## Addendum No. #02

January 4, 2024

Meadow Heights MP Building INC-2  
2619 Dolores St.  
San Mateo, CA 94403  
DSA#: 01-120018 INC-2

#### 2 DUCT SUPPORT DETAIL - CONCEALED DUCTWORK

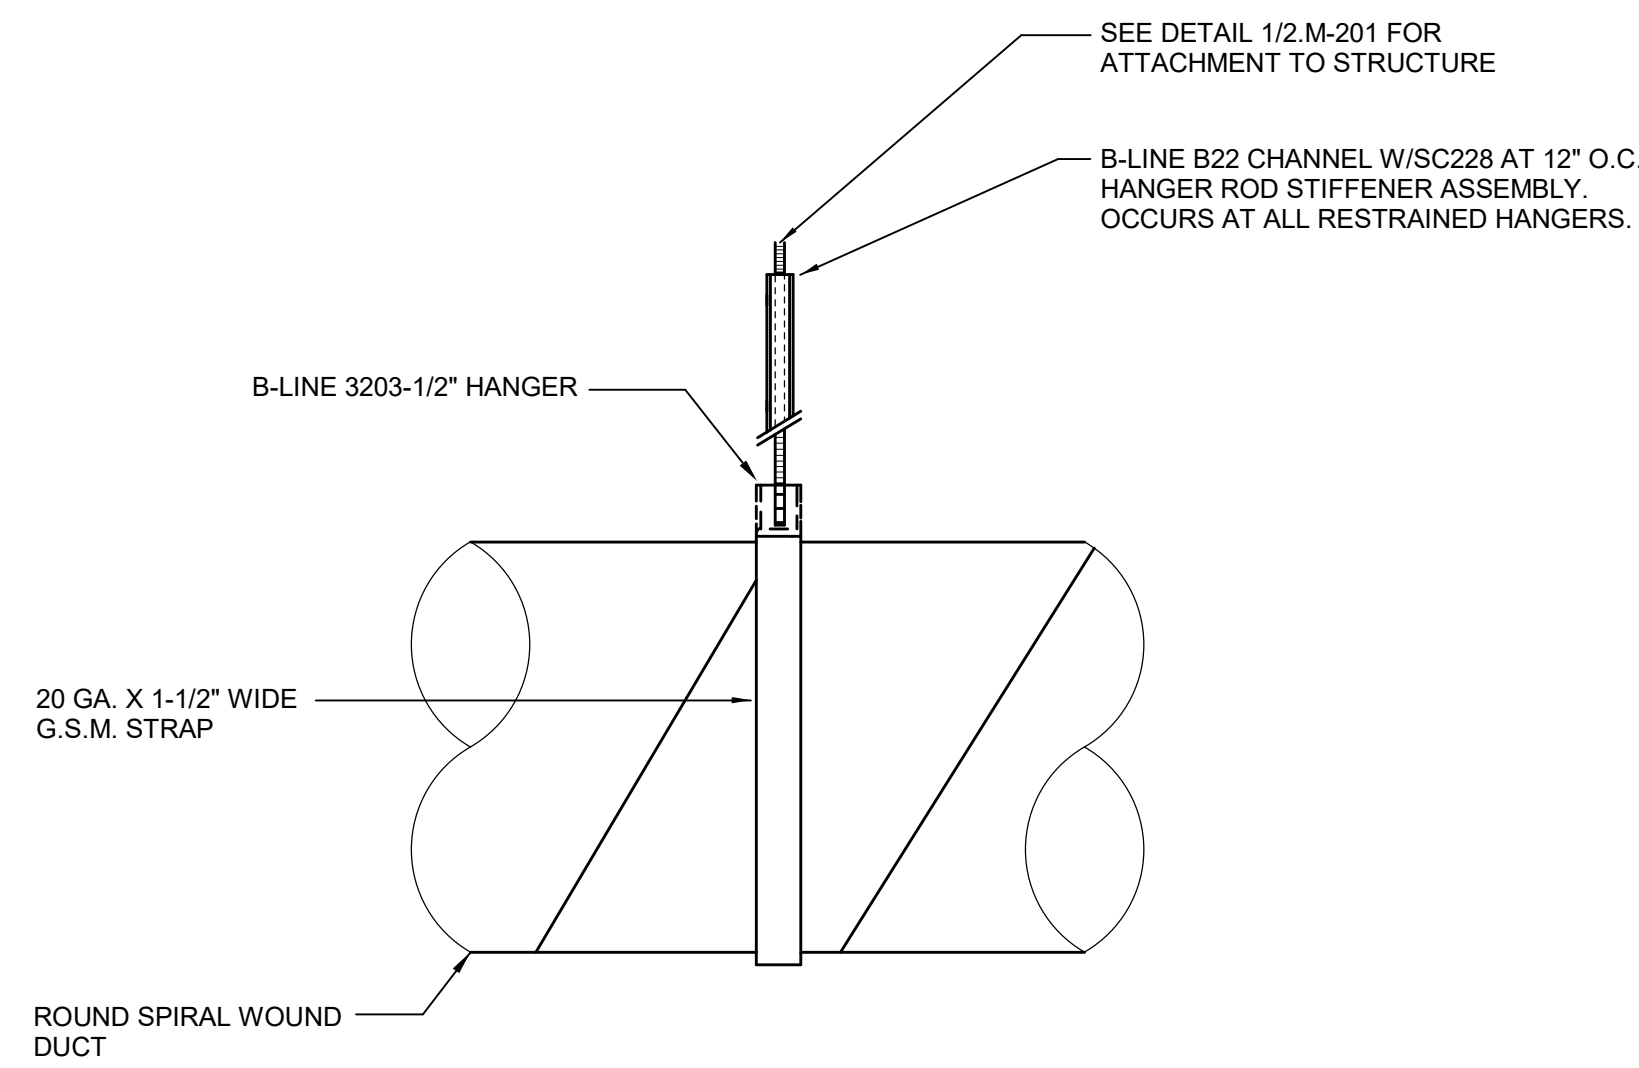
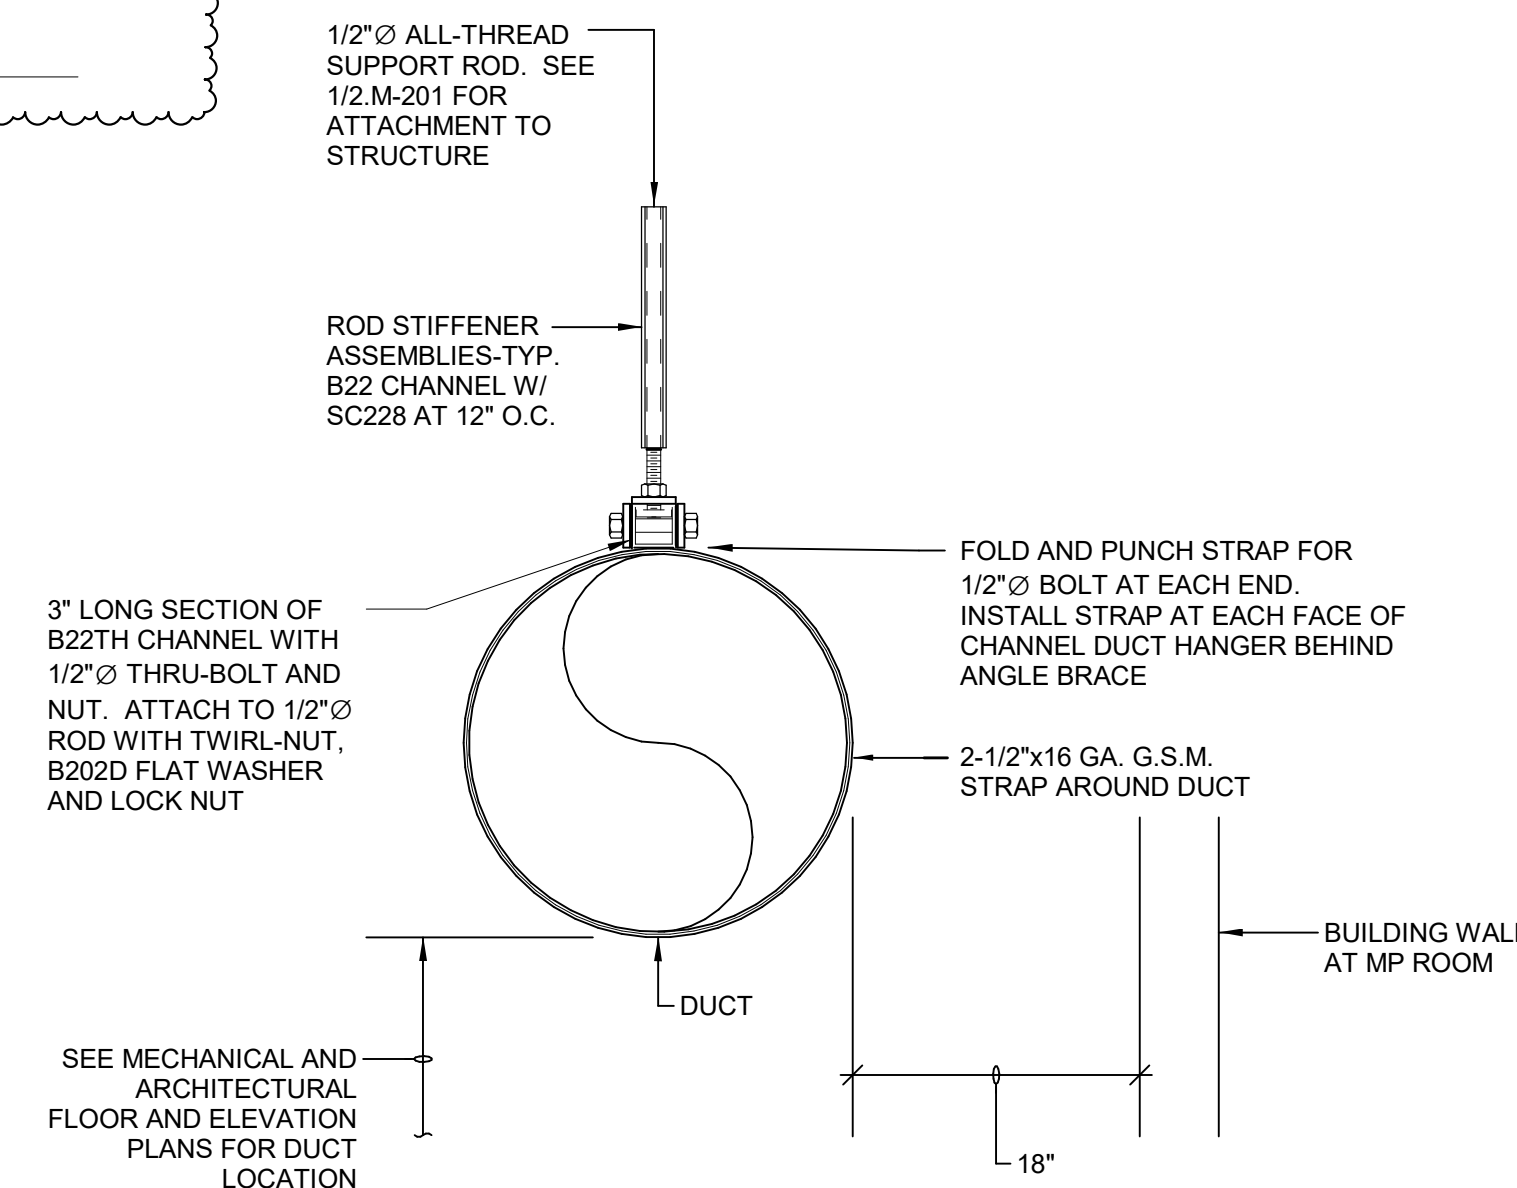
10. **Question:** Per mounting details 2 and 3/ 2.M-201 do the rod stiffeners and struts must only be B-line product? (SC228 and B22 channel) Or can we use other brands?

**Answer:** Other manufacturers are acceptable providing they are an OPM certified seismic restraint system.
